AGENDA

La Vergne Planning Commission
January 27, 2026 at 6:00 PM

Planning Commission Report
Meeting: January 27, 2026

P:\2025\20250029_alliance lavergne multifamily\dwg\construction\20250029_GRA.dwg-GRADING & DRAINAGE PLAN Dec 22, 2025 rhudson

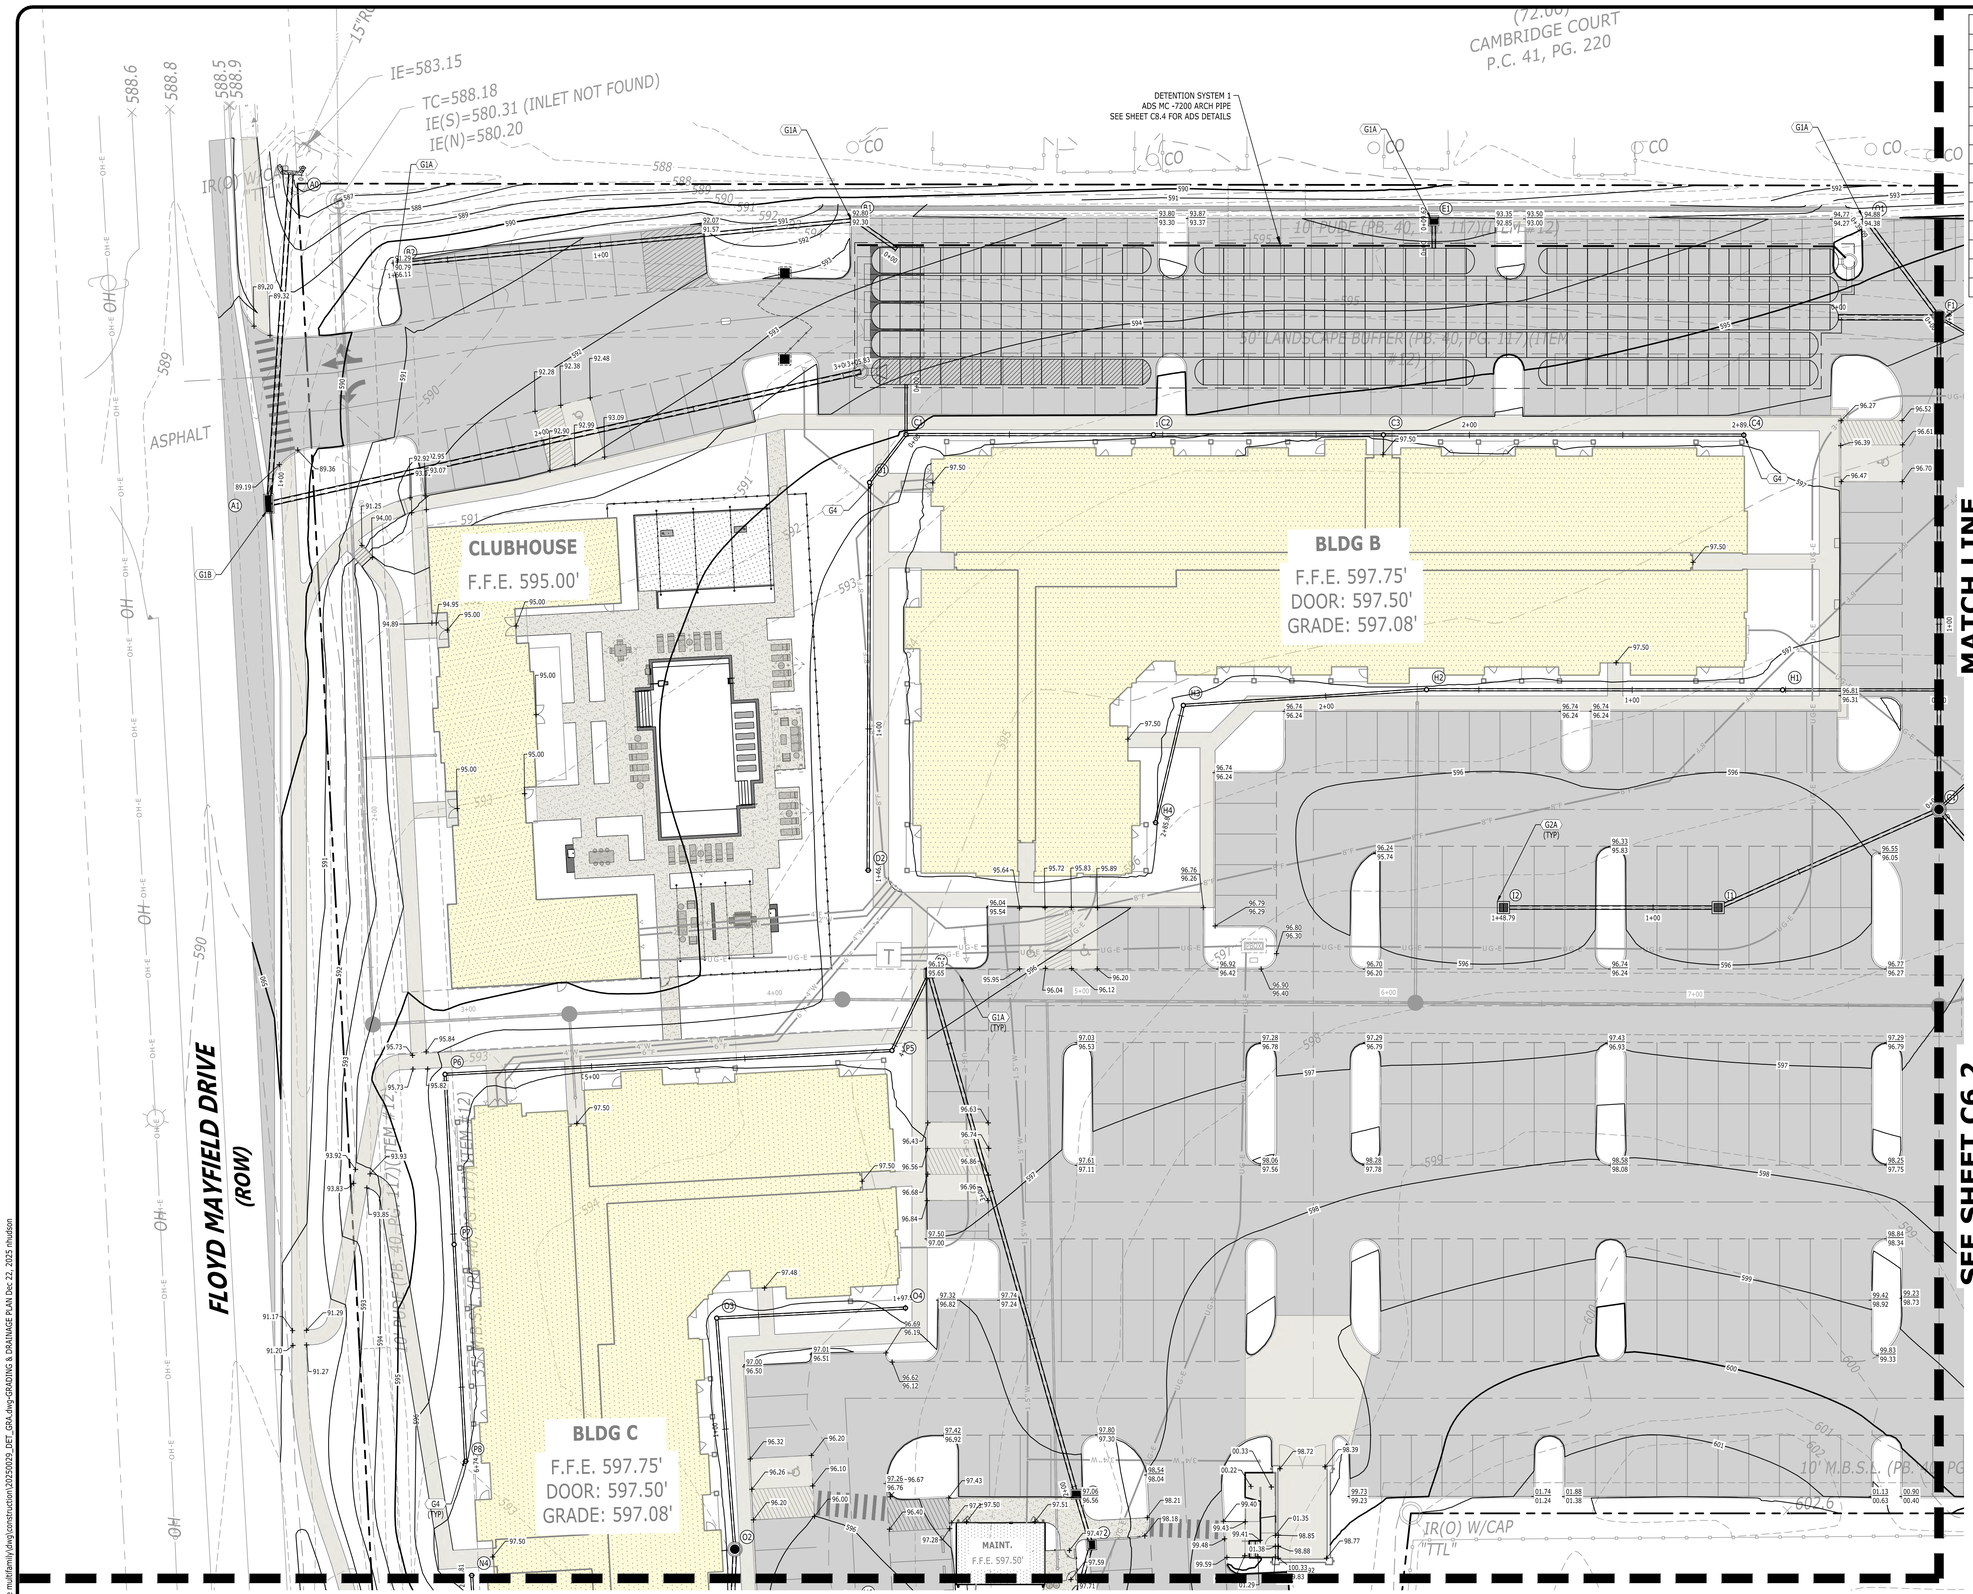
4. (Sheet C6.1 and Stormwater Calculations) The existing 15” pipe at the northwest property corner is tied into a controlled elevation detention system. All calculations must assume a minimum water surface elevation of 585.50 at Structure A0. For Detention01, calculate the stage discharge for the detention system by starting with the tailwater elevation of 585.50 at Structure A0 and then calculating the elevation in structure A1 based on that. Use the calculated WSE in structure A1 as a tailwater to then calculate the WSE at location DET1. Include all flows into these pipes. Use these water surface elevations to calculate the stage-discharge from the underground detention.

13. (Sheet C6.1) Provide sufficient elevation and grade information in the area between the clubhouse and the pool to demonstrate that there is sufficient fall to get stormwater out of that area. It does not appear that this is the case from the present plan.

24. (For Information Only) (Sheet C6.1) Since retaining wall is less than four feet high, no detailed structural drawings are required.
25. (Sheet C5.3 and LSP1.0) Label and show dimensions for the open area that appears to be a dog park.

27. (Sheet LSP1.0) Show locations, dimensions, and descriptions of proposed monument signs.
28. (Sheet C6.1) The grading plan for the vicinity of the accessible parking spaces south of Building B show spot shots which indicate that water will pond in the space west of the accessible spaces. Provide detailed information to show how water will drain out of this area.

29. (Sheet C6.1 and C6.2) Label curb cuts on grading plans as well as site plans.
30. (Sheet C6.1 and Stormwater Calculations) The existing 15" pipe at the northwest property corner is Perforated HDPE and not RCP.

DRAWING NUMBER
C6.3

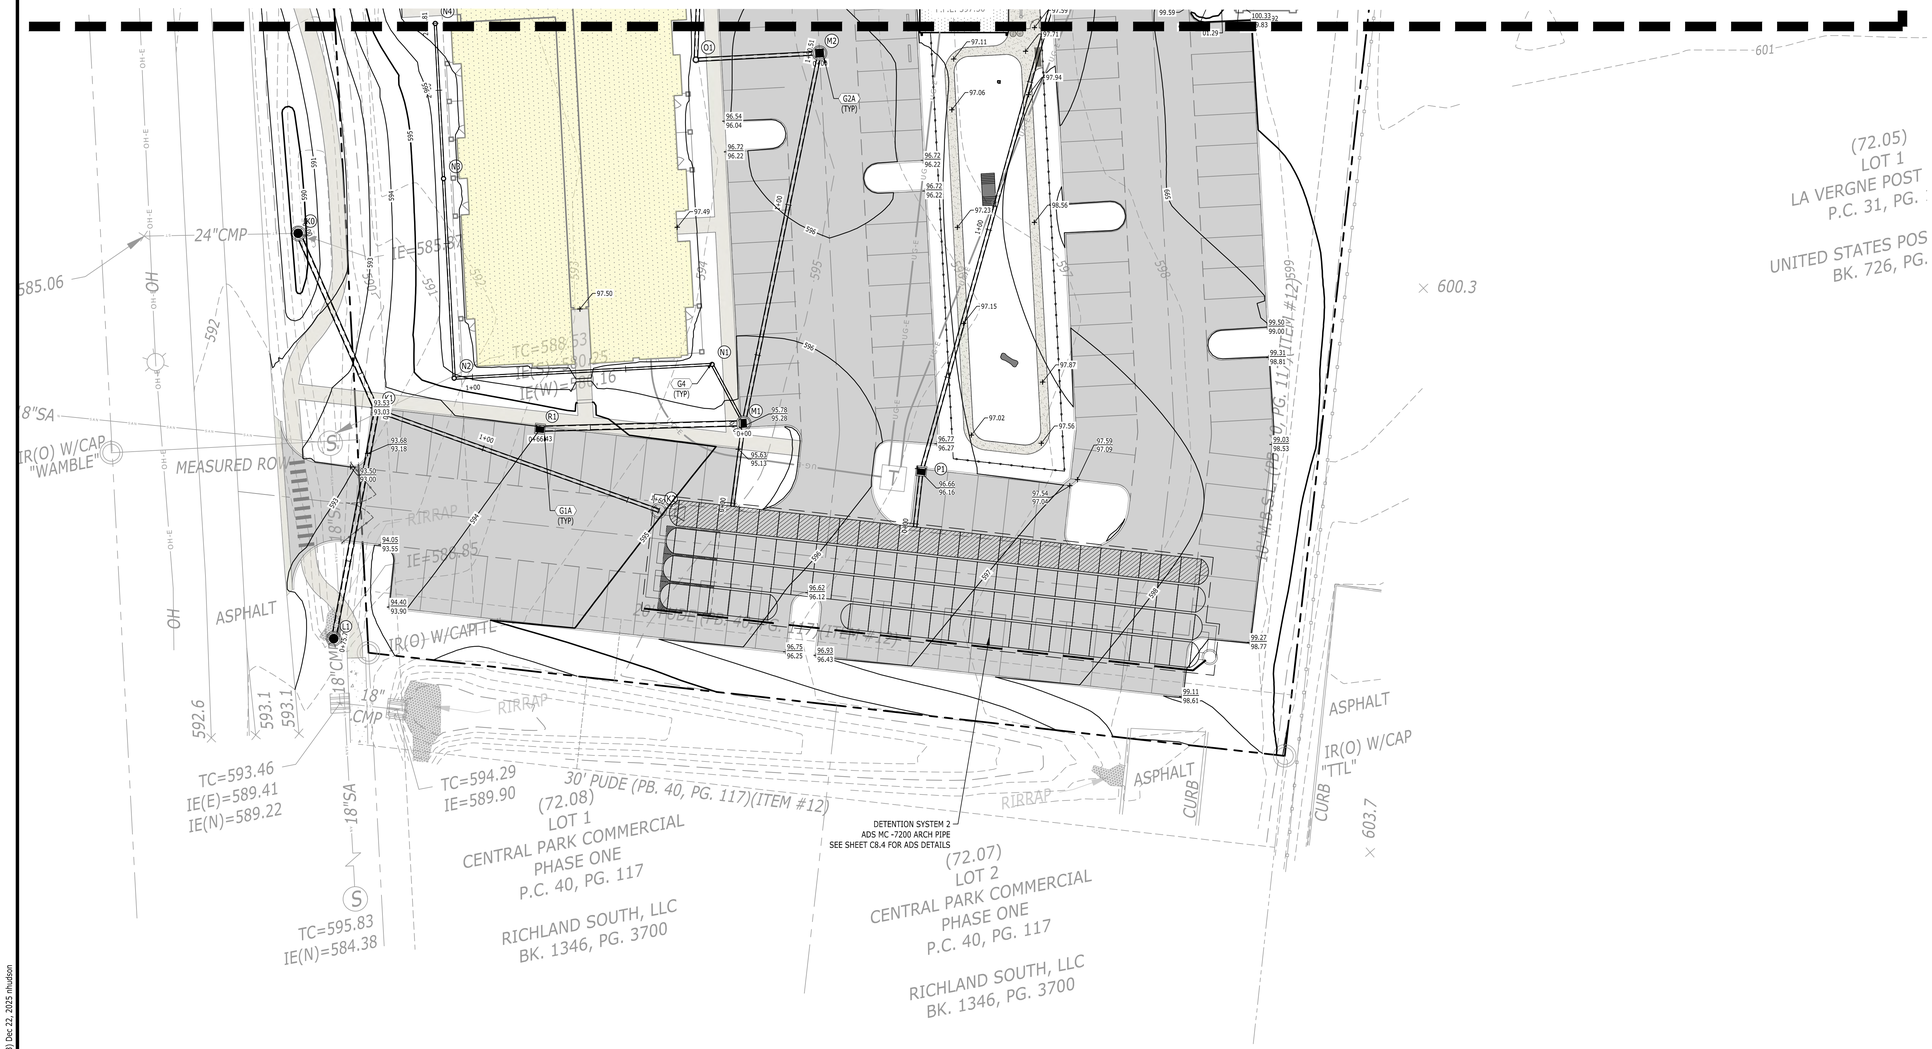
31. (Sheet C6.3) The way the 593 contour and, to a lesser extend, the 592 contour are shown at the edge of pavement (EOP) will cause water to run along the EOP further causing erosion and pavement failure. Show a clearly defined swale which is away from the EOP.

32. (Sheet C6.3) Provide a TC Elevation and Invert for Structure K2 and rename Structure K@ to DET2 to match tables on Sheet C6.4.
33. (Sheet C6.4) Provide size, material, and slope for Pipe K2 to K1.

DRAWING NUMBER
C6.4

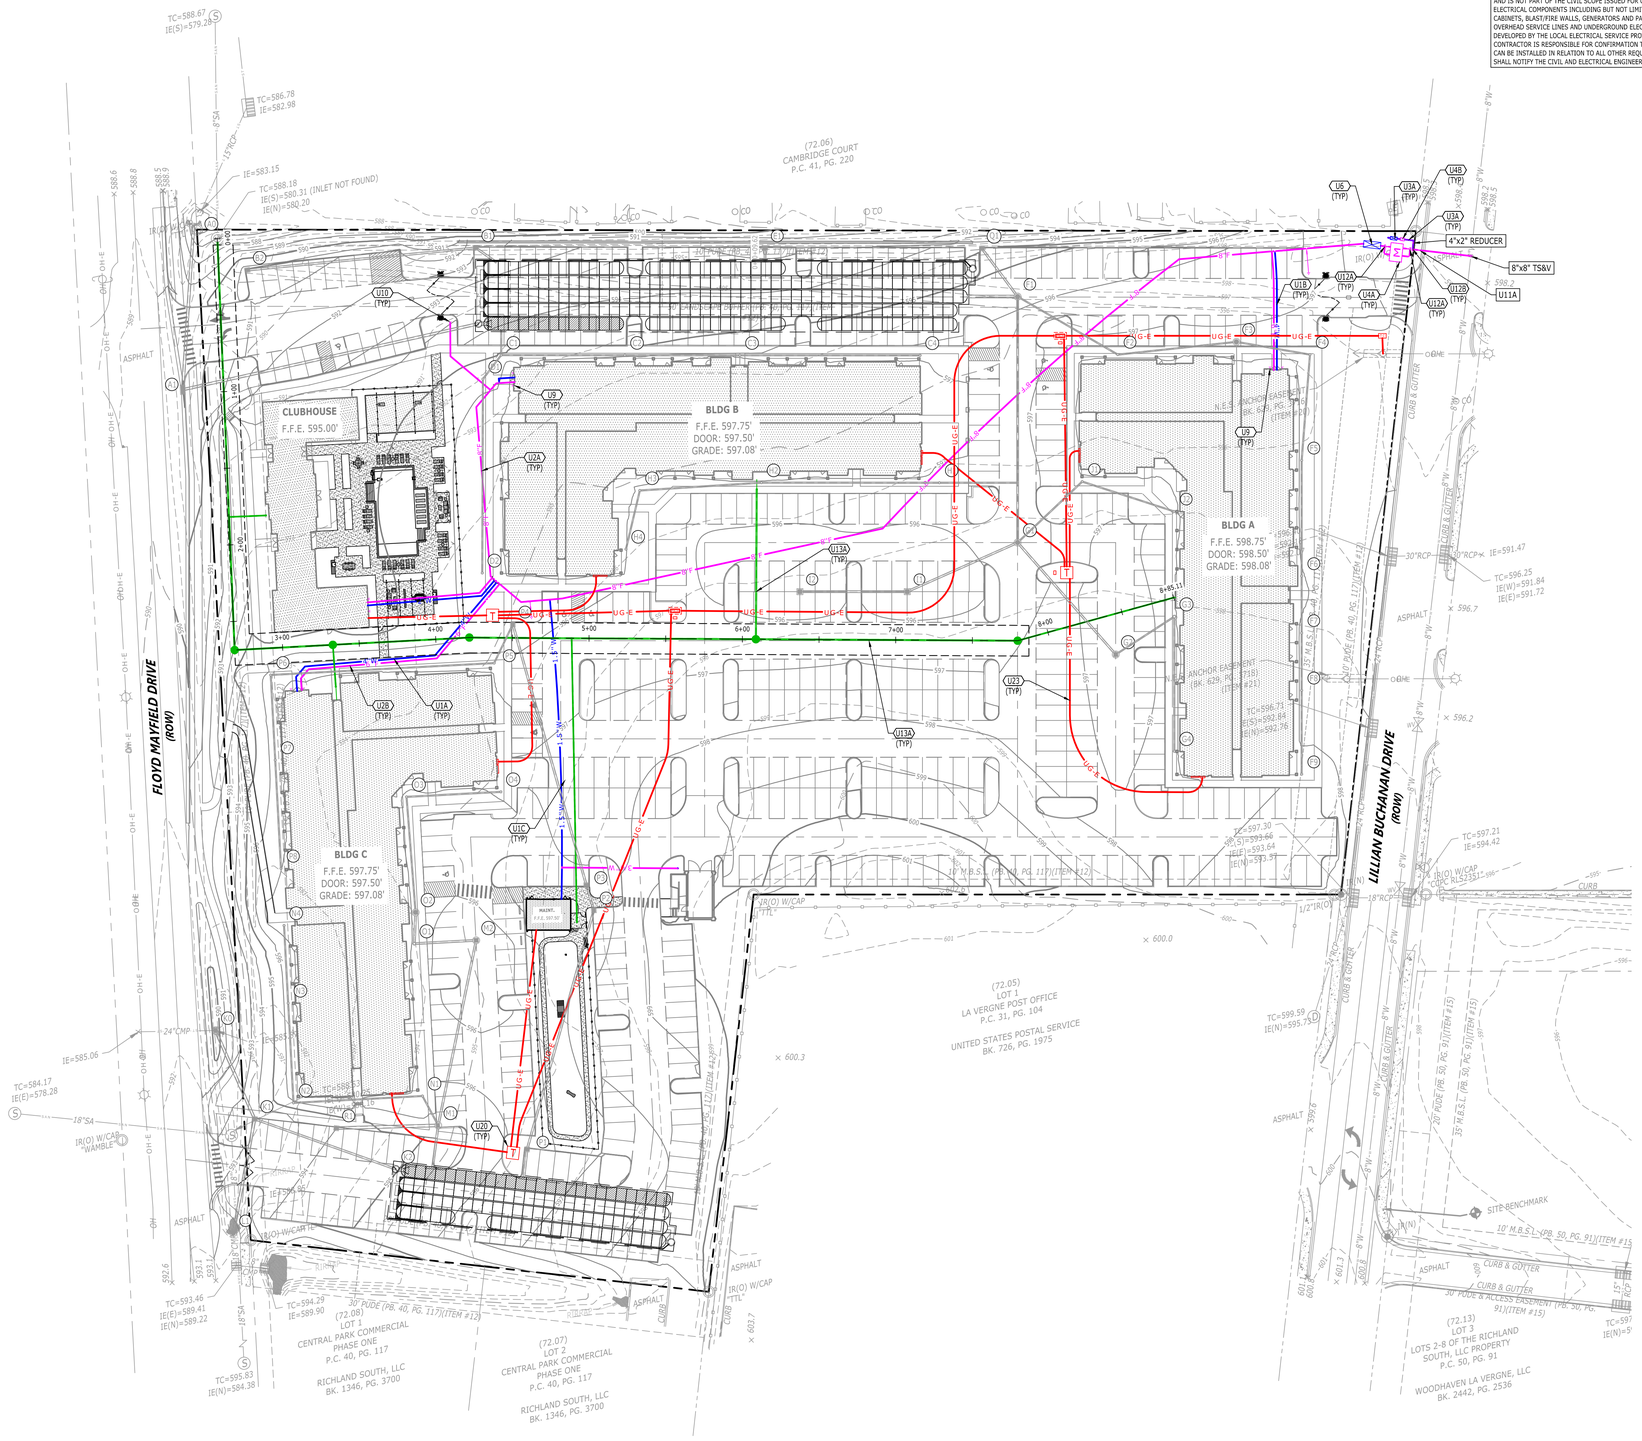
7. (Sheet C6.4) Change pipes L1 to K1 and K1 to K0 from 15” to 18” to match existing upstream pipe which is tied to them.
8. (Sheet C8.4) For both items ‘G’ (Outlet Control Structure OCS), this sheet says “Design by Engineer/Provided by Others”. Provide this design and include the rectangular orifices matching the calculations.

34. (Sheets C6.1, C6.3, and C6.4) Provide Label, TC Elevation, and Invert for manhole access into the east end of the underground detention systems.
35. (Sheet C6.1 and C6.4) Label structure DET1 and provide TC Elevation and Invert.(Stormwater Calculations) Provide inflow and bypass Q calculations for curb inlet A1 for the 25-year/24-hour storm.
